Our Reference      160787-01-01L-DD  
Rev 01

**Acoustic Review and Assessment  
Southern Acoustic Barrier  
Mulgrave Substrate Plant, Mulgrave**

**Figure 1: Site Layout (Drawing No. 200608 Issue J)**

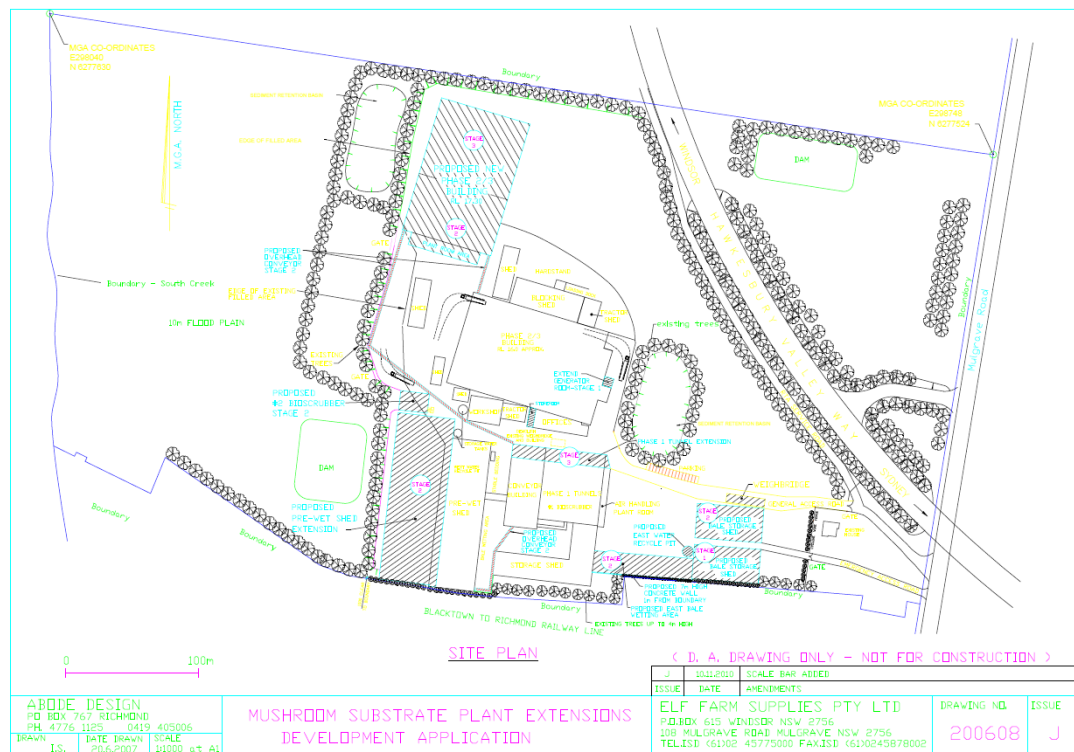
The 2010 noise modelling and assessment relied on information provided by Elf Farm Supplies Pty Ltd, Perram and Partners and Abode Design (Drawing No.: 200608 Issue J). A review of the concept drawing identified a seven (7) metre high wall extending from the bale storage sheds west towards the raw materials storage area. The purpose of this wall was to provide structural support for a boom watering system for pre-wetting of the straw bales prior to processing. The acoustic assessment considered this acoustic wall for the noise modelling, rather than the acoustic assessment recommending a specific wall height.

Elf Farm Supplies Pty Ltd is seeking to clarify and modify the southern acoustic wall requirements and reduce the wall height from the seven (7) metres, which was proposed for structural reasons to support the bale pre-wet boom system. The 2012 approved eastern external bale wetting area as identified in DWG 200608 J is no longer required (as noted in the 2015 Mod 1 EA).

The original seven (7) metre high barrier as documented on Design Drawing No.: 200608 Issue J was intended to provide structural support to the bale wetting boom equipment. The height of this wall was not driven by acoustic requirements, and the concept wall height was simply adopted in the 2010 and 2014 noise assessments. As the eastern external bale wetting area identified in DWG 200608 J is no longer required, the height of the acoustic wall to the south and east of the bale storage area could be amended.

- bale unloading, storage and transfer of bales within the bale storage area utilise the existing Hyundai HL757-9 and Liebherr 550 front end loaders, or equivalent loaders with an operating sound power level of not more than 98dB(A);
- existing reversing beepers on loaders be replaced with broad band level varying 'quacker' reversing alarms; and
- acoustic wall (Hebel, precast concrete or equivalent) be constructed to the south (adjacent southern boundary) and east edge of the bale storage area not less than four (4) metres above finished ground level of area (nominally RL16) resulting in a nominal barrier height of RL20.
